Title: Calidus airframe inspection			
AG-SIL-2019-01-B-EN		Compliance Category:	
Applicability		A - MANDATORY	
Aircraft type & model: All AutoGyro Calidus	Affected aircraft serial numbers: All AutoGyro Calidus	B – RECOMMENDED C - OPTIONAL	
The maintenance manual to be referenced is this stated or subsequent issue.		As per AutoGyro website	
This form is the response from AutoGyro GmbH either against a problem found in the product in service requiring a containment or rectification action, or as service information for aircraft modification incorporation. For help, contact AutoGyro on 49(0)5121 88056-00, or email airworthiness@auto-gyro.com.

Reason and overview of the Service Information Letter (cause of problem if known)

Service Information Letter

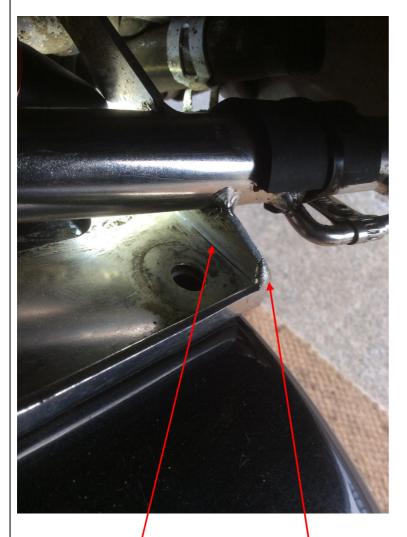
Check in right-hand upper body bracket weld

Crack position (could be either side of the mast) between the rear bracket and the mast/keel tube

View of crack in the leading edge of the folded bracket area. This is visible from outside front of the bracket. Also check the corner bracket weld
